Gasco Production Company Gate Canyon State #12-21-11-15 1793' FNL and 717' FWL SW NW Section 21, T11S-R15E Duchesne County, Utah

Application for Permit to Drill Statement of Basis

ON-SITE PREDRILL EVALUATION

2008-04 Gasco Gate Cyn ST 12-21-11-15

5000 psi system

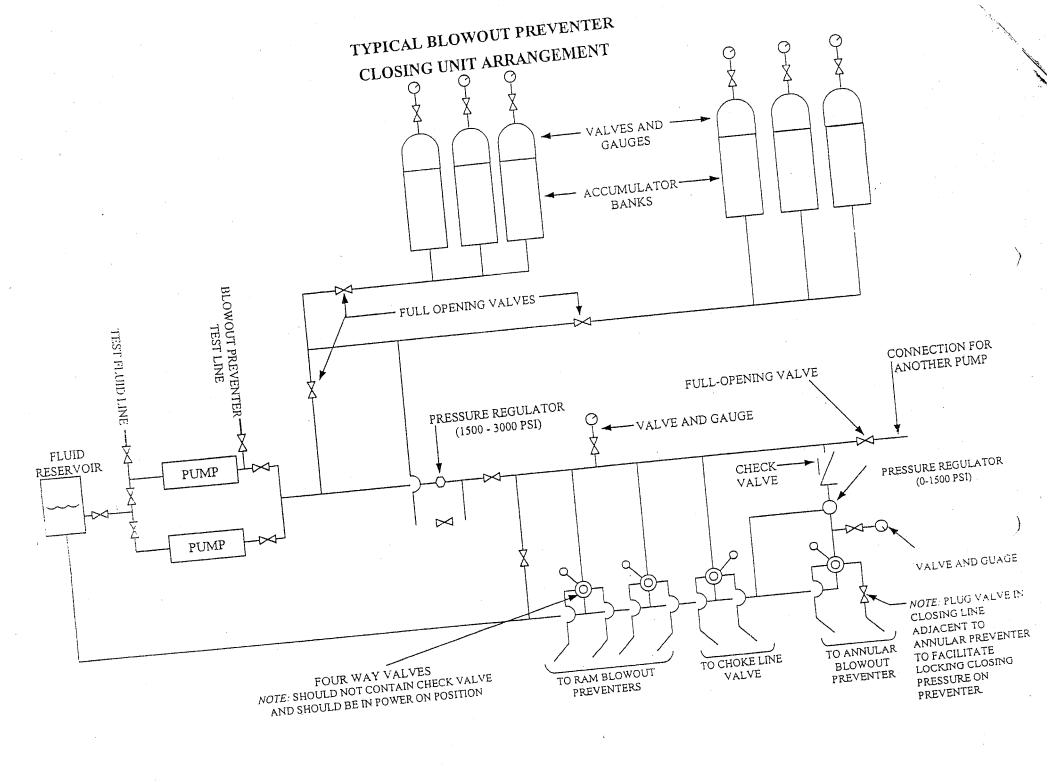
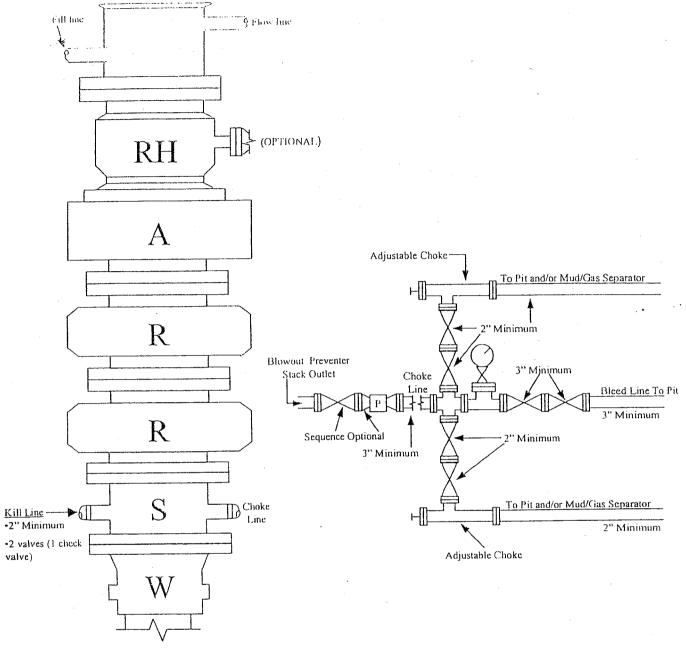
The state called regarding the Gate Canyon 12-21-11-15 and the Wilkin Ridge 43-36-10-17. They are wanting to know what the well control will be for the Intermediate Casing. Can you get me some verbiage and I will pass it on?

Both these wells will have a single ram, mud cross, double ram and an annular. For both of these wells the BOP's will be 10K and the annular 5K. Let me know if you need anything else.

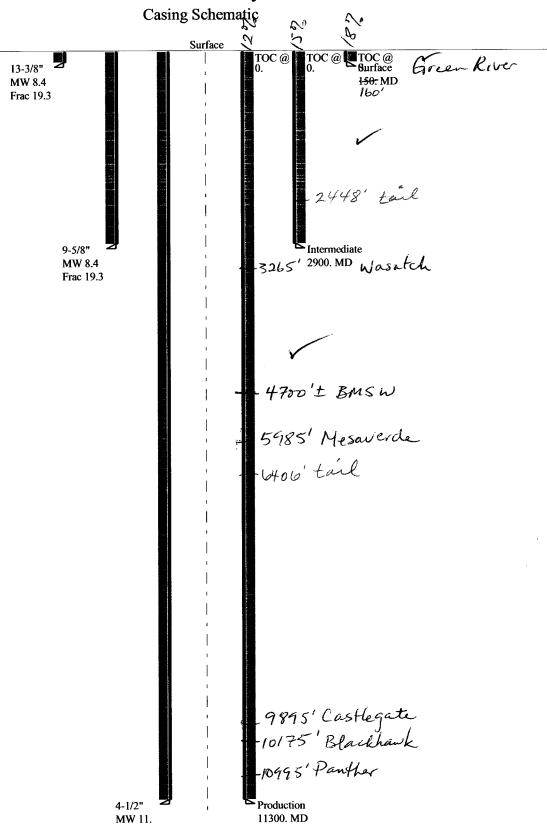
The planned reserve pit is 100' by 140' located within a cut area on the on the southwest side of the location. It is 10 feet deep with a 10-foot wide bench. Stability should not be a problem. A 16 mil liner is required.

Closed Loop Mud Required? N Liner Required? Y Liner Thickness 16 Pit Underlayment Required? Y
